Application for Licence Amendment

Licence Number	L4597/1988/14
Licence Holder	Barto Gold Mining Pty Ltd
ACN	161 566 490
File Number	DER2014/000887-1~13
Premises	Southern Cross Operations MARVEL LOCH WA 6426 Mining Leases M77/7, M77/8, M77/10, M77/26, M77/31, M77/66, M77/72, M77/86, M77/109, M77/112, M77/113, M77/114, M77/133, M77/137, M77/138, M77/159, M77/175, M77/193, M77/197, M77/198, M77/217, M77/221, M77/224, M77/225, M77/239, M77/251, M77/347, M77/352, M77/380, M77/408, M77/424, M77/431, M77/432, M77/525, M77/554, M77/555, M77/593, M77/631, M77/638, M77/640, M77/660, M77/655, M77/668, M77/702, M77/745, M77/721, M77/746, M77/747, M77/722, M77/765, M77/766, M77/768, M77/775, M77/790, M77/791 M77/792, M77/793, M77/794, M77/811, M77/969, M77/977, M77/1009, M77/1036, M77/1052 and M77/1275, Miscellaneous Licences L77/51, L77/87, L77/106, L77/112, L77/113, L77/114, L77/126, L77/128, L77/162, L77/167, L77/168, L77/173, L77/281, L77/290 and General Purpose Leases G77/1-3. As defined in Licence L4597/1988/14

Date of Report	17 February 2025
Decision	Revised licence granted

Figure 1: Area A from M77/109 to be excised from Licence

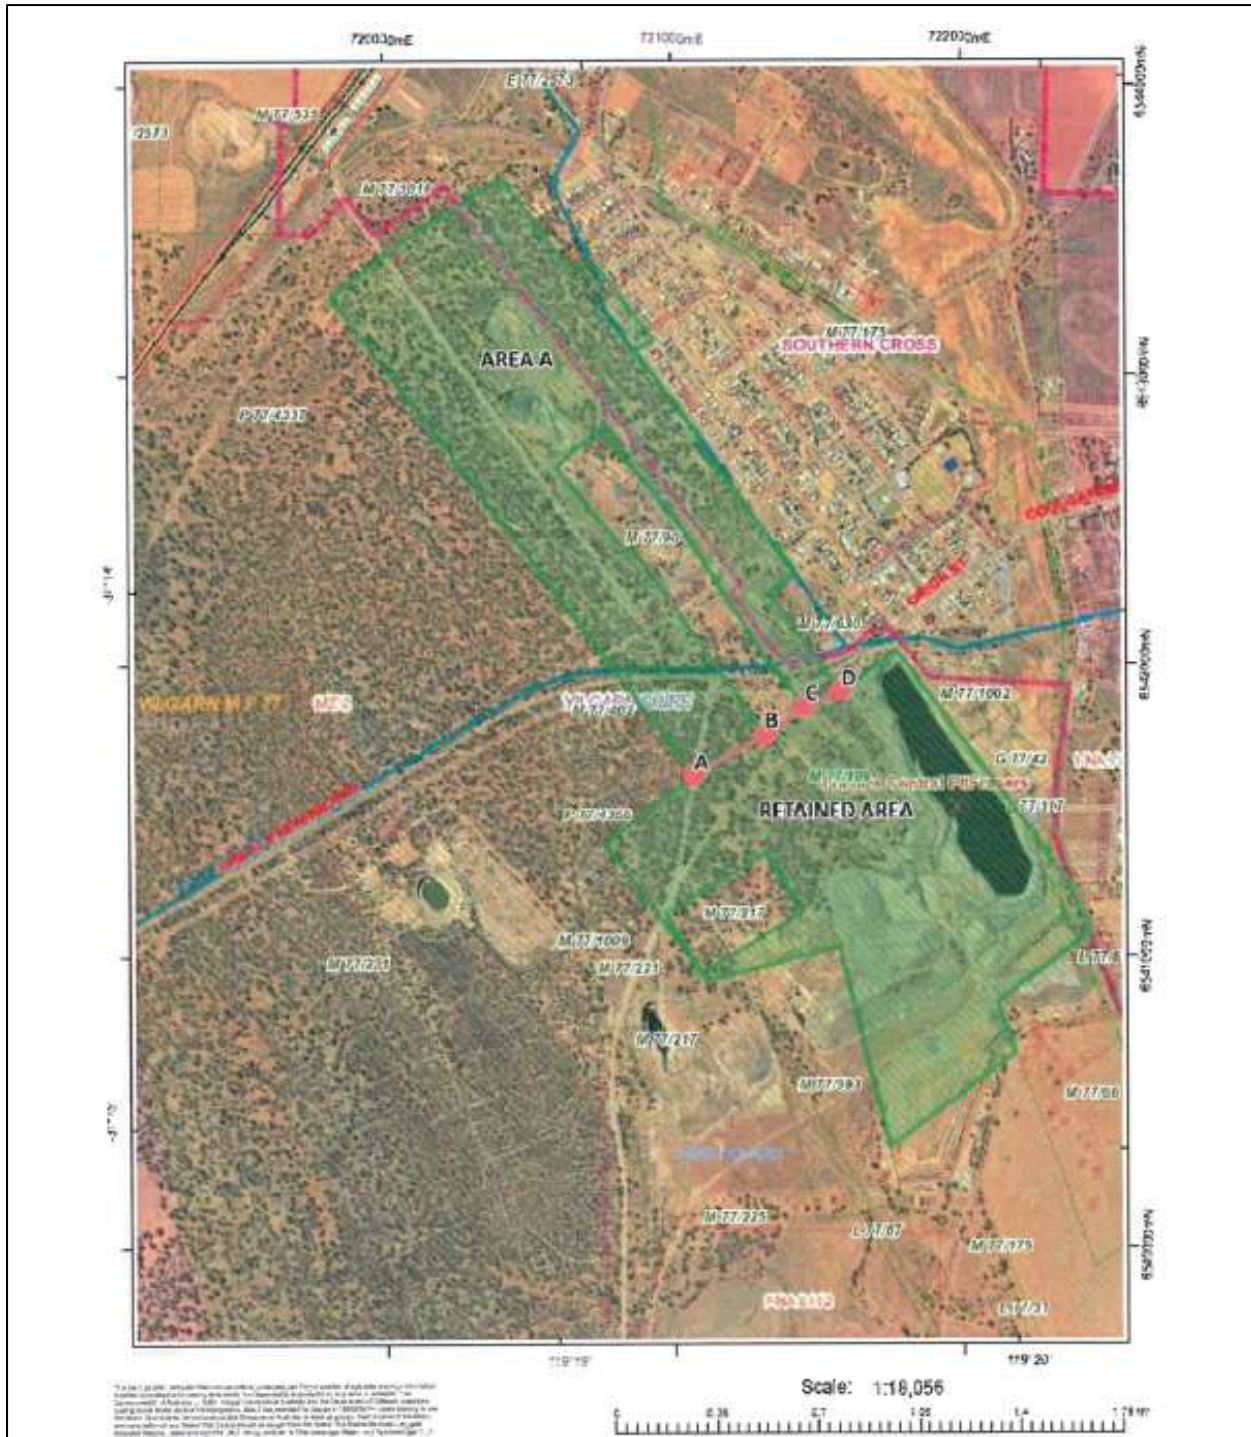
In December 2022, the Licence Holder and Cygnet entered into an agreement for the sale of 46 tenements in the Southern Cross region. This sale didn't include mining tenement M77/109, but did include a sale of the mineral rights to a portion of mining tenement M77/109, know as 'Area A' and detailed below in Figure 1.

As part of this application, the Licence Holder would like to annex 'Area A' from its prescribed premise boundary, which would allow Cygnet to apply for its own licence. There are no discharge points or licensed infrastructure on this portion of tenement M77/109.

The Department has determined to grant this request.

Figure 3: Location of groundwater monitoring bores surrounding TSF3

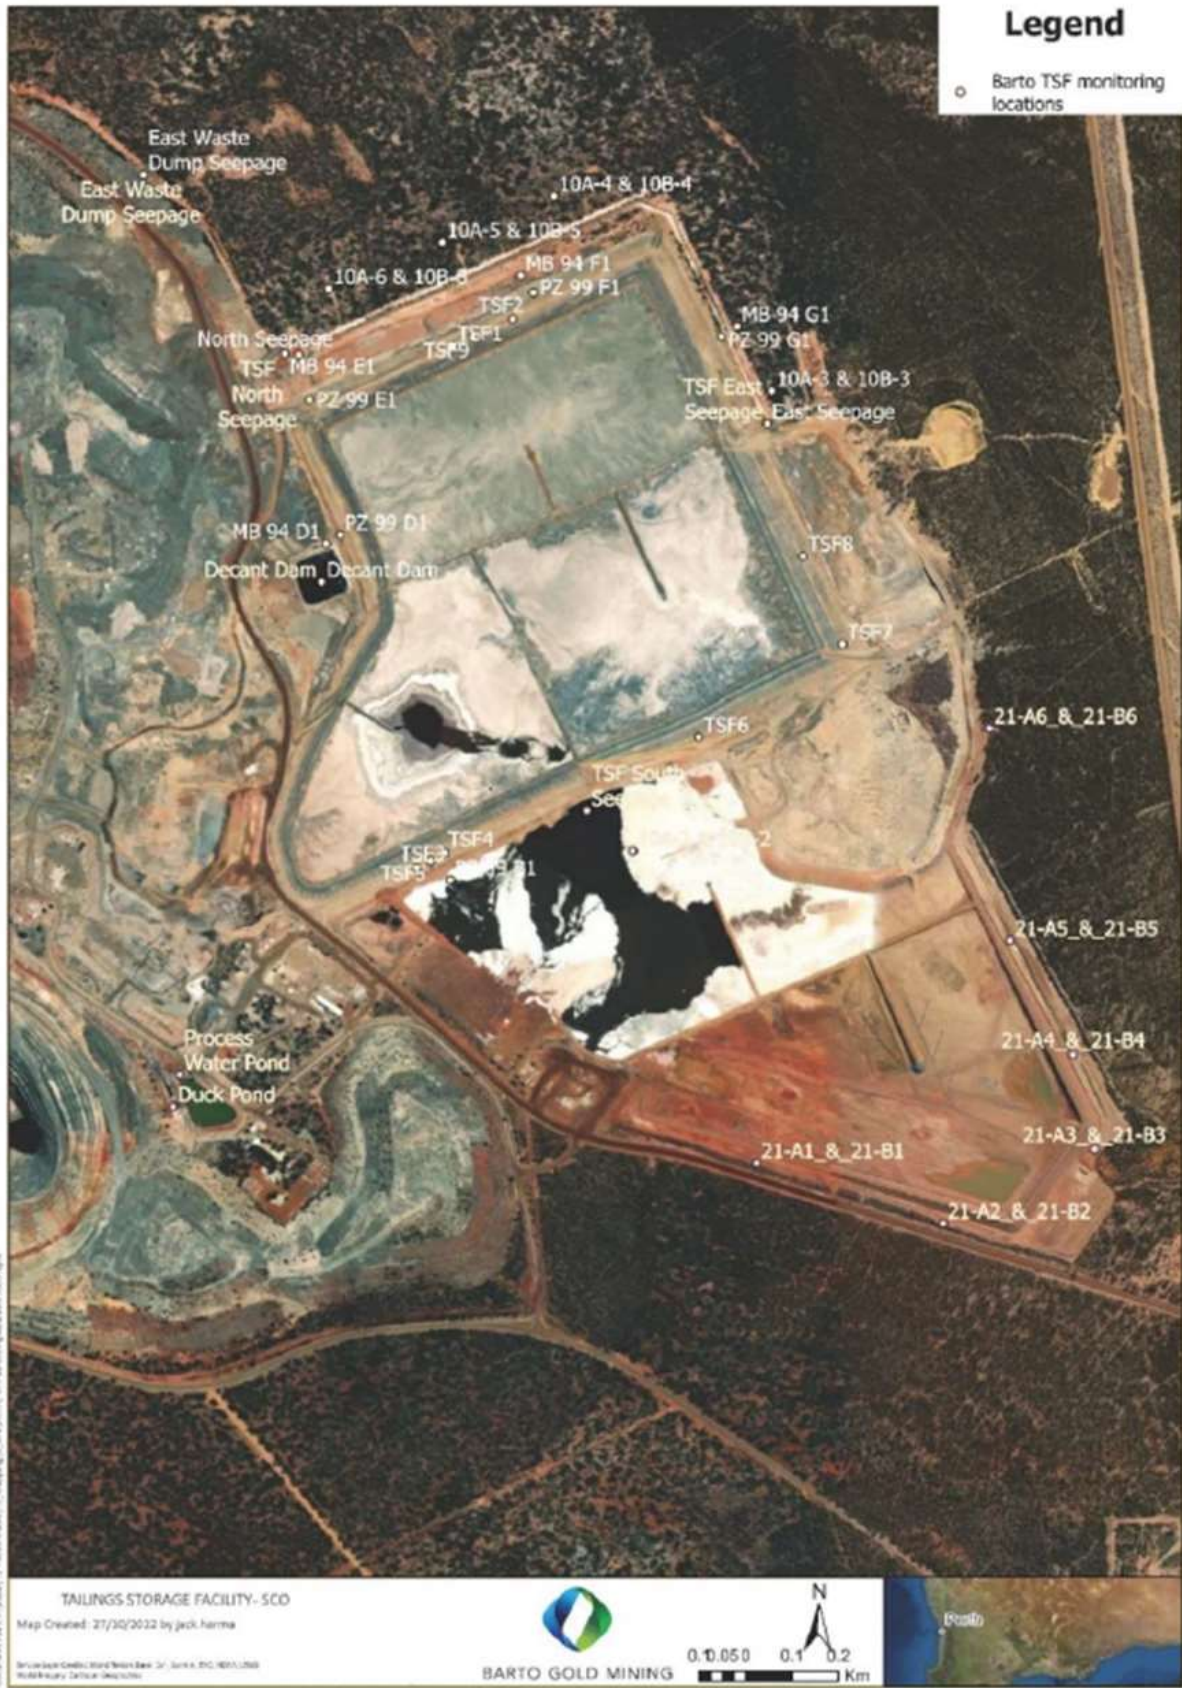
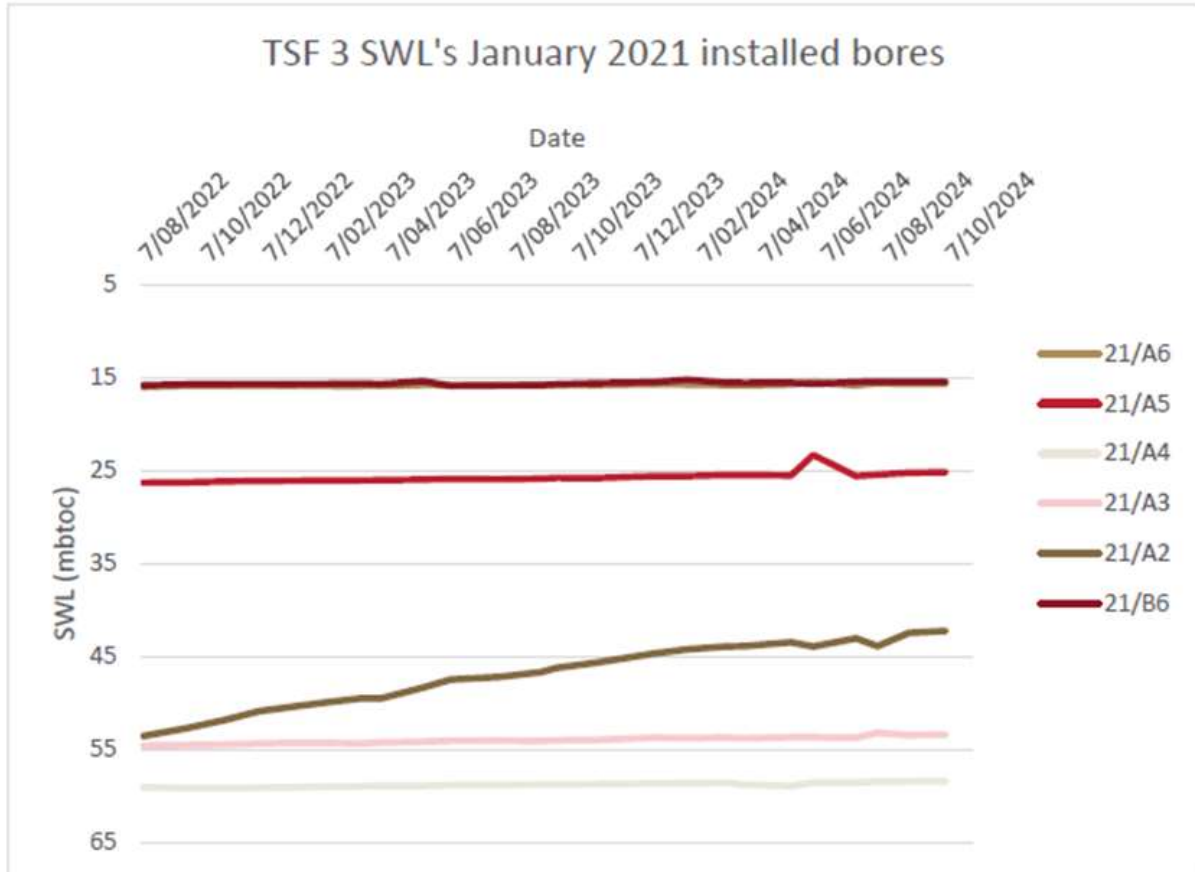
Figure 4 outlines the standing water levels (SWL) (in meters below top of casing (mbtoc)) over the last two years within the monitoring bores surrounding TSF3. The shallowest groundwater level observed around TSF3 in 2024 was observed in monitoring bore 21/B6 at 15 mbtoc. Over time, SWL at groundwater monitoring bores around TSF3 have remained relatively stable since the 2022 annual period, with the exception of bore 21/A2 which demonstrates a rising trend. At the time of this assessment none of the monitoring bores associated with TSF3 have exceeded the SWL limit of 4.0mbgl, specified within the licence.

There are no strong indications of groundwater mounding observed at any of the monitoring bores immediately adjacent to TSF3 (except for bore 21/A2) at this stage. However, the next 5 stages of embankment lifts for TSF3 are planned to occur over the next 3.5 years. These embankment raises will increase the storage capacity of TSF3 significantly from 6 million tonnes to 17 million tonnes. In turn this will increase the hydraulic head under the TSF which is likely to cause some mounding of the groundwater table in the future. It is important that the monitoring bore network is sufficient to ensure groundwater mounding is identified and management actions (groundwater recovery) is implemented before impacts to vegetation occurs.

Over time, SWL at groundwater monitoring bores around TSF3 have remained relatively stable, with the exception of bore 21/A2 which demonstrates a rising trend. No explanation for this trend has been given. Monthly SWLs should continue to be measured in the subsequent reporting period, with commentary on the rising trend of 21/A2 provided in future annual reports.

It has been determined however that due to the significant increase in tailings storage capacity over the next 3.5 years, a review of the groundwater bore monitoring network surrounding TSF3 is to be undertaken to ensure that it is adequate to monitoring mounding impacts in TSF3's zone of influence.
